**SUBJECT: REVISION "A" TO TECHNICAL BULLETIN 407-07-75:  
FADEC ECU EMC-35 WITH REVERSIONARY GOVERNOR,  
INTRODUCTION OF.**

No. 407-07-75

**MODEL AFFECTED:** 407

**SUBJECT:** FADEC ECU EMC-35R WITH REVERSIONARY GOVERNOR, INTRODUCTION AND INSTALLATION OF.

FIGURE 1. ECU installation

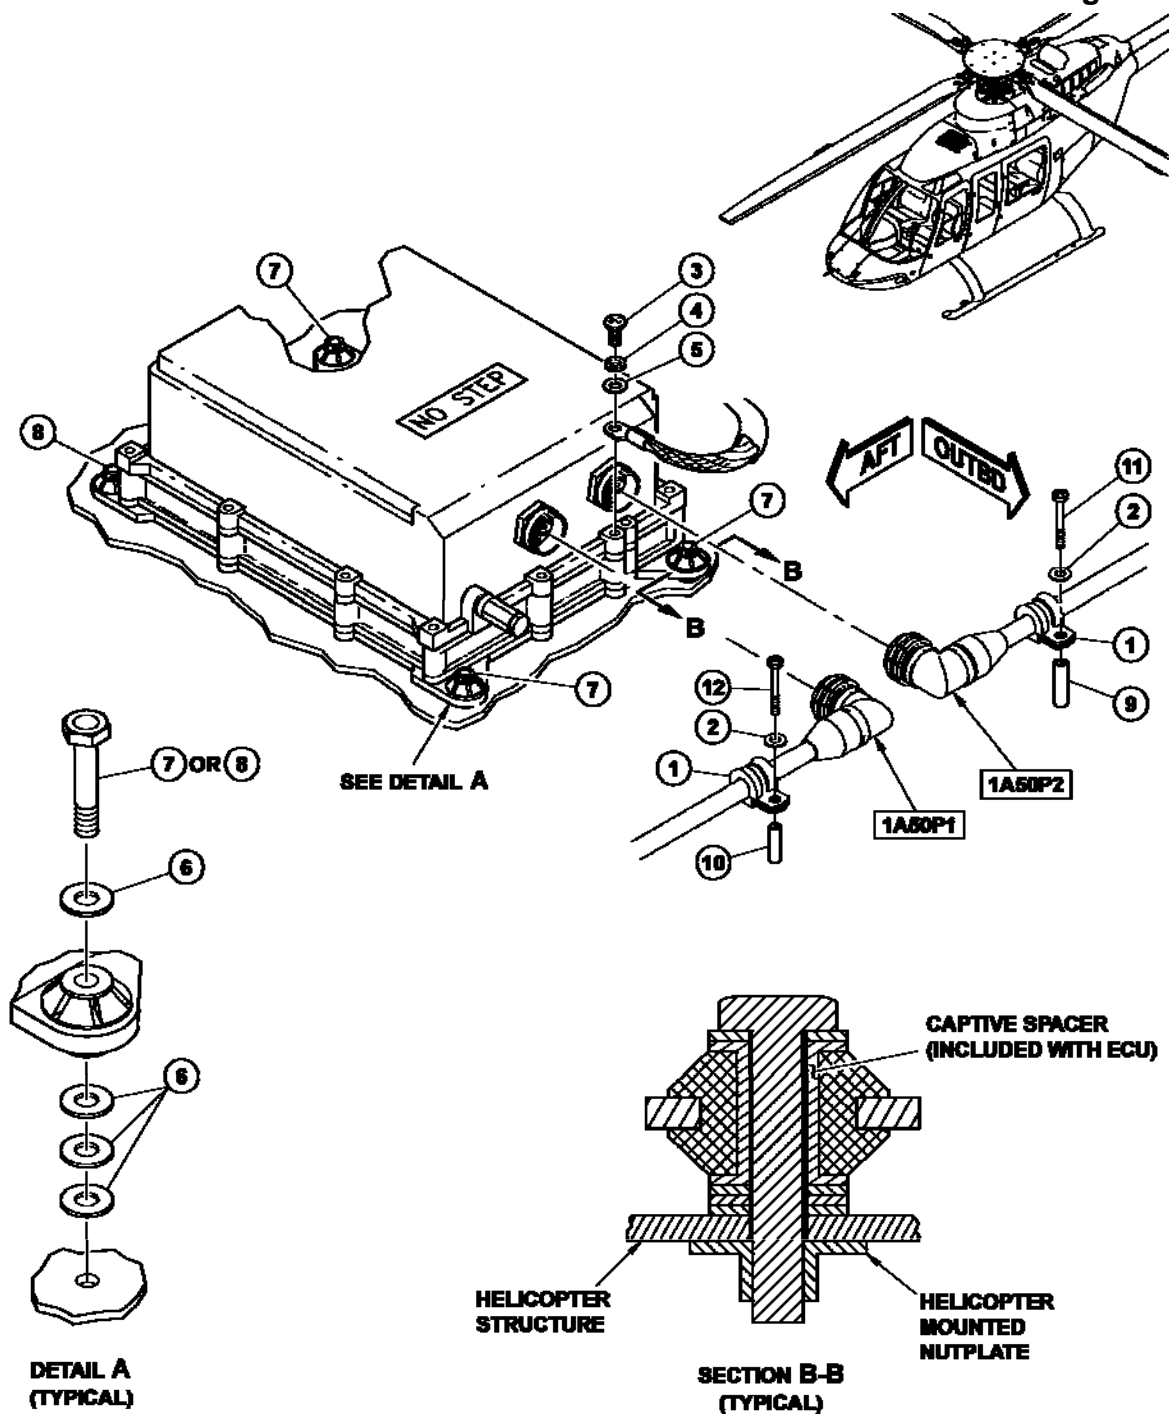
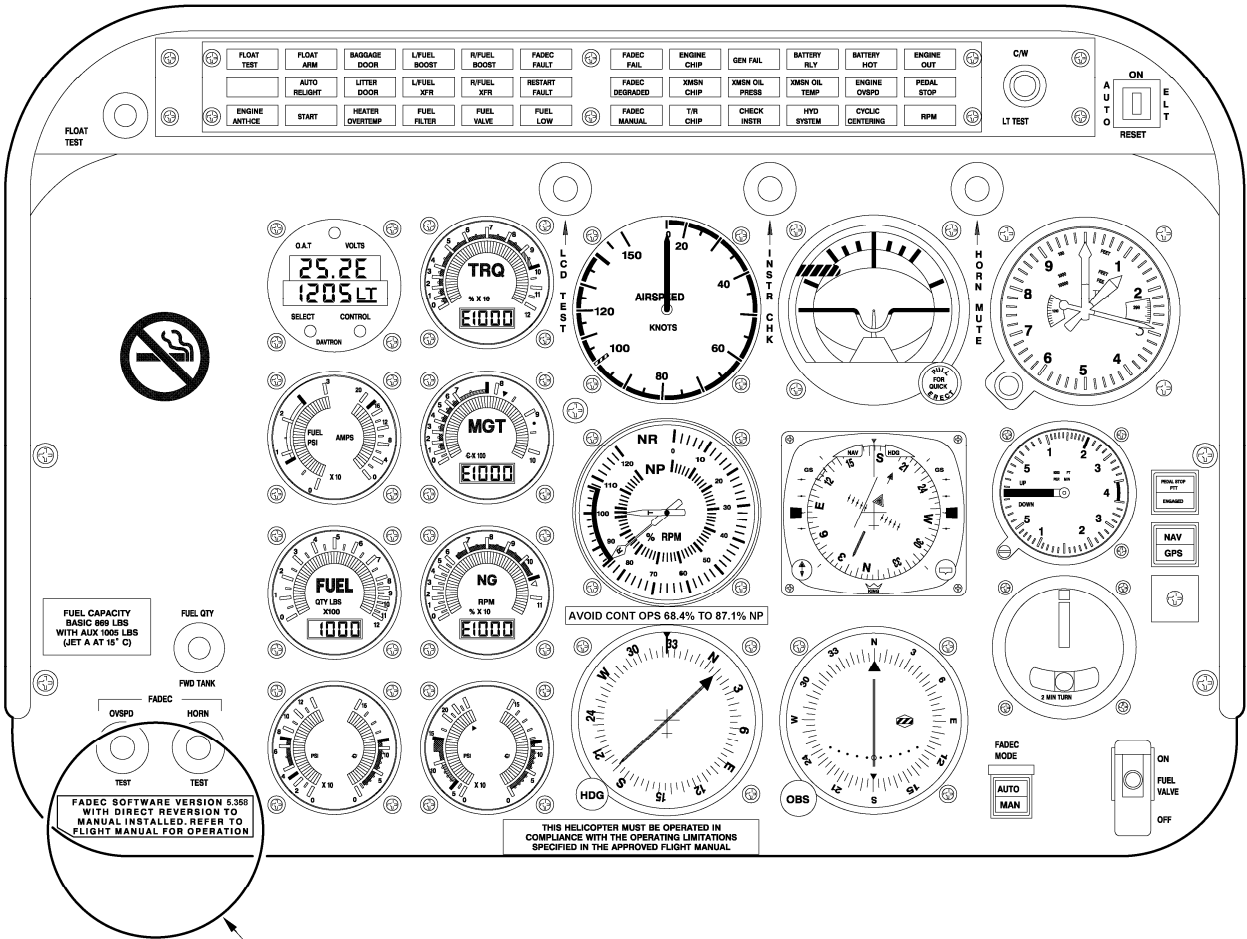
4. Disconnect clamps (1) currently holding the cable assemblies 407-375-012-101 (or 407-076-503-111) and 407-375-012-103 (or 407-076-503-109) to the roof deck that are adjacent to the ECU connectors 1A50P1 and 1A50P2. Refer to Figure 1.
5. Disconnect the FADEC harness electrical connectors 1A50P1 and 1A50P2 from the ECU.
6. Remove the screw (3), lock washer (4), washer (5) and the bonding strap from the ECU. Retain hardware.

7. Remove bolts, washers (6) and spacers holding the ECU to the deck.
8. Remove ECU P/N 23072790.
9. Install ECU P/N 23088484 using hardware as shown in Figure 1.

10. Re-install bonding strap using screw (3), lock washer (4), washer (5) onto the ECU.
11. Ensure connectors 1A50P1 and 1A50P2 are clean and in a serviceable condition and install to the ECU. If applicable, re-install clamp (1) and washers (2), removed in Step 4, and spacers (9 and 10). Refer to Figure 1

Figure 2. Instrument Panel Decal Location

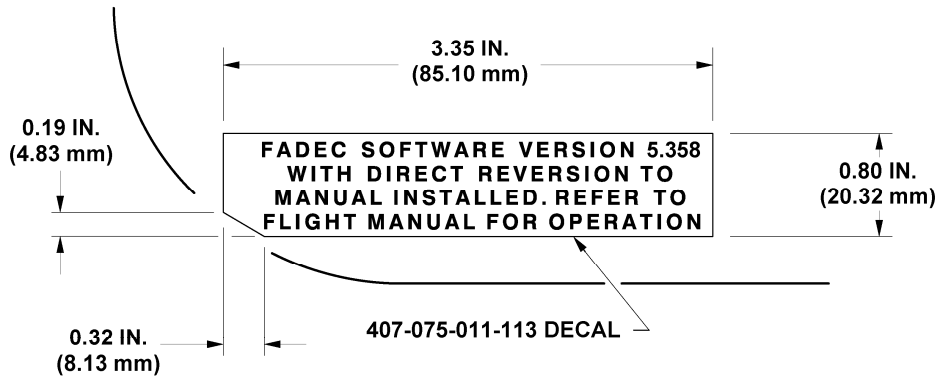
**Note 2:** The decal may be locally manufactured using lettering of white color no. 17875, on a black background color no. 17038 per FED STD595. Characters to be 12 points Helvetica Regular, the text for the decal is detailed in figure 2, detail C.

13. Install decal 407-075-011-113 on instrument panel. Refer to Figure 2.
14. Seal edges of decal using edge sealer (C-349).
15. Re-install all cowlings previously removed (BHT-407-MM, Chapter 53 – Fuselage).
